REDE[illegible]LL COUNTY HEALTH DEPARTMENT

IMPROVEMENT PERMIT / AUTHORIZATION TO CONSTRUCT / OPERATION PERMIT / EXISTING SYSTEM INSPECTION

PERMIT# 12273 PIN# 4636328692,033 4636326527 DATE 7-6-06

SUBDIVISION Cove on Chesapeake PH BLOCK / SECTION ____ LOT 33 LOT AREA .69 Acre SITE CLASS. PS DESIGN FLOW 480gpd L.T.A.R. .25 to .3

AS BUILT SKETCH

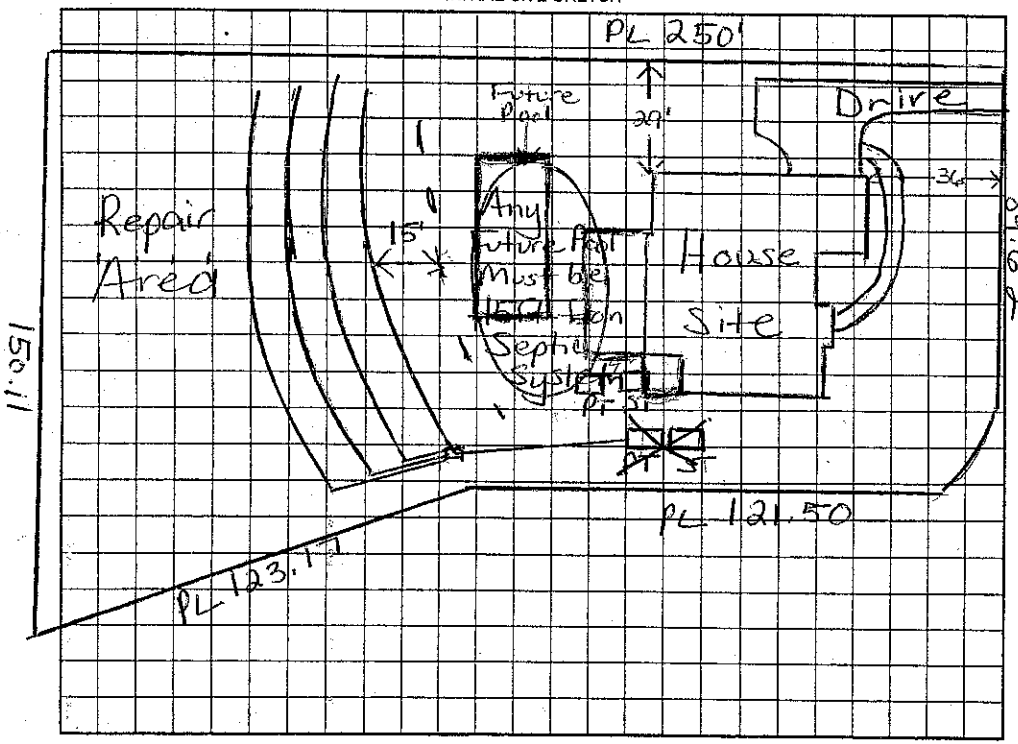
Comments:/Conditions: Note: Okay to Center feed lines
*Use In line filter in PT
Scale 1:50

Comments:/Conditions: Keep any future swimming pool at least 15ft from Septic System. Checked tanks 7/21/06 Checked lines & pres. 7/[illegible] 3/16" hole drilled

The proposed / existing Inground Swimming pool addition does not appear to impact the existing septic system

**NOTE: Must keep Pool Cut at least 15ft from Septic Maria Dotson REHS
